Re: Docket No. 7508 - Georgia Mountain Community Wind, LLC

**SUBJECT:** McDaniel Complaint

FIGURE 1: COMPLAINANT LOCATION

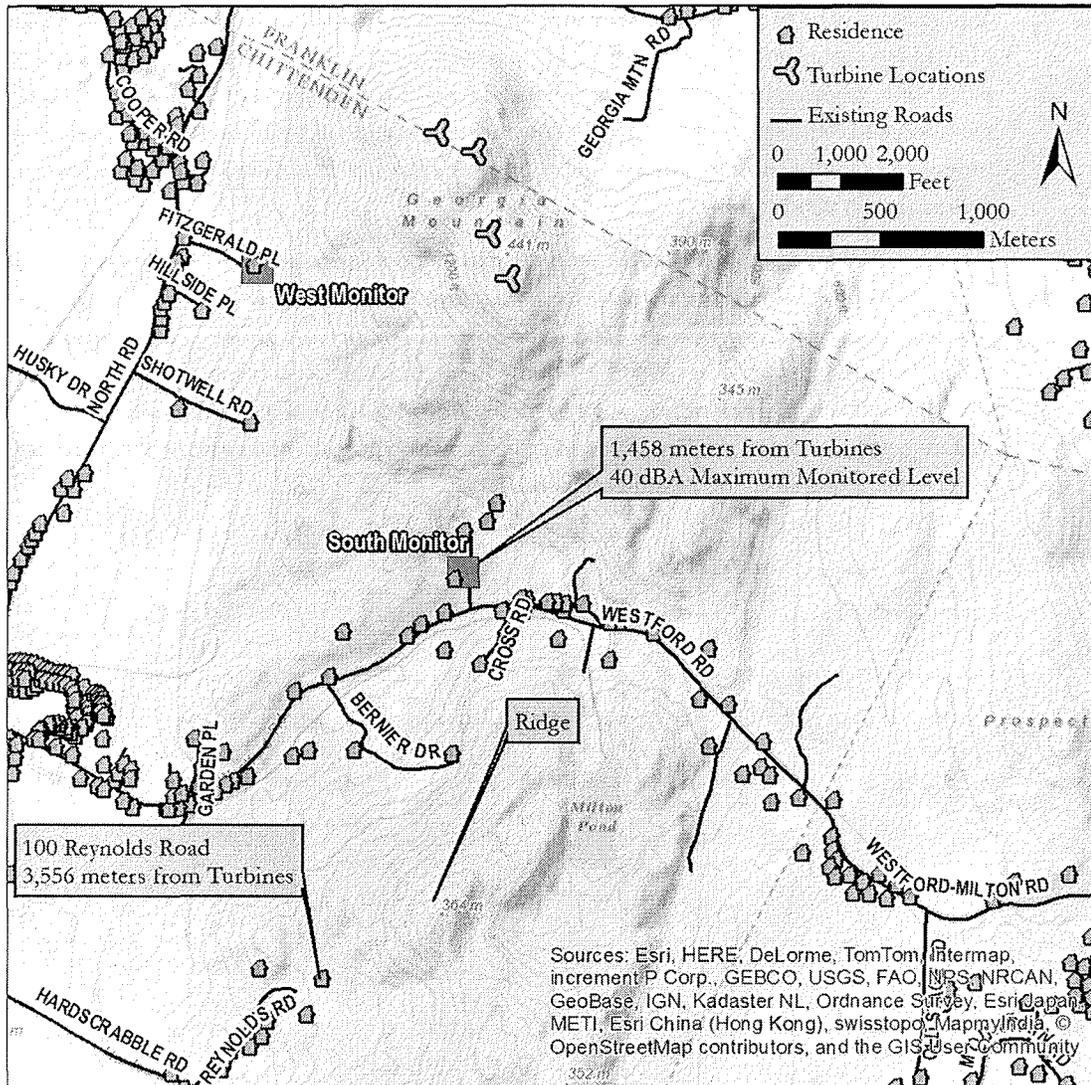
The complainant property is 3.5 km (2.2 miles) from the project and thus does not meet the requirements for further investigation under the sound monitoring protocol noted above (see map on page 3). Nonetheless, we offer the following additional information relevant to this property.
